## Product / Process Change Notification (PCN)

### Honeywell Juarez Optoelectronica

PCN #	0171	Notification Date:	4/29/21
Title:	Product Change Notification for change of temporary packaging box		
PCN type:	Notification only <input type="checkbox"/>	Authorization	<input checked="" type="checkbox"/>
<b>Honeywell Contact</b>			
Name:	Fabiola Barraza	Title:	Sr. Quality Engineer
Business Phone:	N/A	Fax #	N/A
E-mail:	Fabiolaedith.barraza@honeywell.com	Date initiated:	4/29/21
<b>Product Identification</b>			
Affected Part # (s)	Microswitch; 11SX21-T, 11SM1-H2, 11SM1-T, 11SM3-T, 11SX21-H58 11SX47-H58, 12SX3-H58, 311SX4-T, 413SX21-T and various.		
Revision # (s)	Various		
Does this change result in product number change?		YES <input type="checkbox"/>	NO <input checked="" type="checkbox"/>
<b>Reason for Change: (check all that apply)</b>			
Material	<input type="checkbox"/>	Processing / Manufacturing	<input type="checkbox"/>
Design / Firmware / Software	<input type="checkbox"/>	Datasheet	<input type="checkbox"/>

The next pictures show Packaging proposal #1

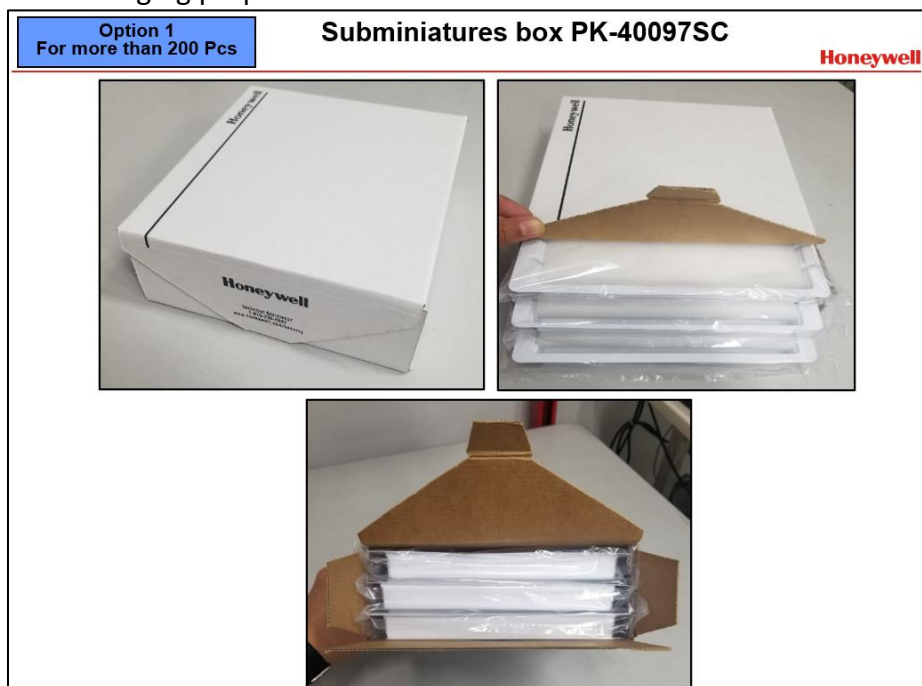
Logistics	<input type="checkbox"/>	Functional	<input type="checkbox"/>
Appearance	<input type="checkbox"/>	Dimensional	<input type="checkbox"/>
Quality / Reliability	<input type="checkbox"/>	Other: Box/ Packing	<input checked="" type="checkbox"/>
<b>Change Description (include detailed process steps as applicable)</b>			
Documentation attached:		YES <input type="checkbox"/>	NO <input checked="" type="checkbox"/>
[Due to material shortage of box PK40095SC, from April 2021 to July 2021, temporary use of box PK-40097SC, which we currently use for switches with leva. Will returned to normal packaging tentative by the end of May 2021]			
<b>Justification for change</b>			
Documentation attached:		YES <input type="checkbox"/>	NO <input checked="" type="checkbox"/>
[Supplier has confirmed shortage of box PK40095SC until July 2021, in order to meet customers demand we will use packaging box PK-40097SC, which is being currently used for some part numbers, option 1 is for orders larger than 200 pcs and option 2 for order smaller than 200 pcs]

<b>Quantifiable impact on Quality &amp; Reliability (Include FMEA / reliability data as applicable)</b>			
Documentation attached:		YES <input type="checkbox"/>	NO <input checked="" type="checkbox"/>
[Box general measurements will change from 7 3/4" X 13/16" X 8 7/16" to 7 13/16" X 2 5/8" X 8 3/8", pieces are protected and immobilized with a foam upon each tray and perfectly fit in a thicker box.]			
<b>Identification method to distinguish change</b>
